PLANNING APPLICATIONS COMMITTEE

31 MARCH 2021

UPDATE SHEET AND ORDER OF CONSIDERATION

Update Report

Proposed Section A
1 : 200

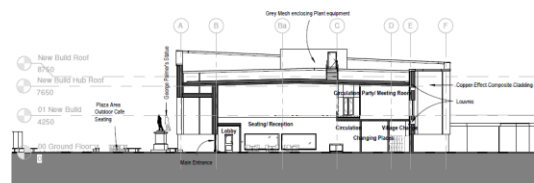
APPENDIX 2: AMENDED PROPOSED SECTIONS
